Product or Process Change Notice Approval (Customer)

PCN Number: PCN-0010-
2016-IH

Title: **ACT8865QI305-T OSAT Change**

POD Comparison

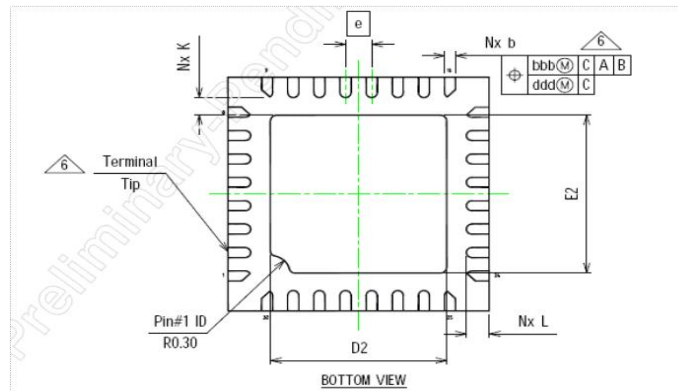
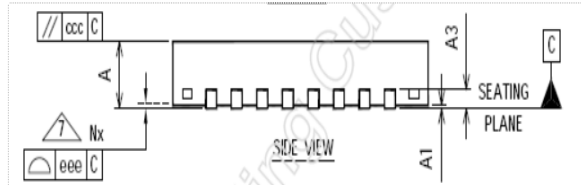
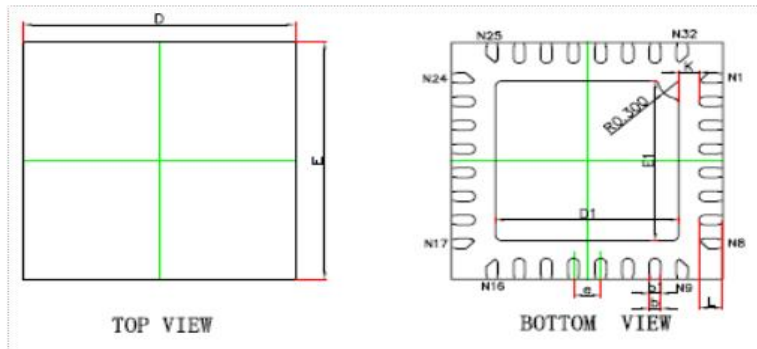
Current: **Current OSAT for ACT8865QI305-T is CARSEM**

Qualify JCET as the OSAT for ACT8865QI305-T, since CARSEM will no longer support us starting this year, 2016..

- Refer to the next page on the details of the difference on the package dimension.

POD	Carsem		JCET	
	Min	Max	Min	Max
A	0.70	0.80	0.70	0.80
A1	0.00	0.05	0.00	0.05
D	3.95	4.05	3.95	4.05
E	3.95	4.05	3.95	4.05
D2	2.55	2.80	2.60	2.80
E2	2.55	2.80	2.60	2.80
e	0.40		0.40	
b	0.15	0.25	0.15	0.25
L	0.25	0.45	0.274	0.426
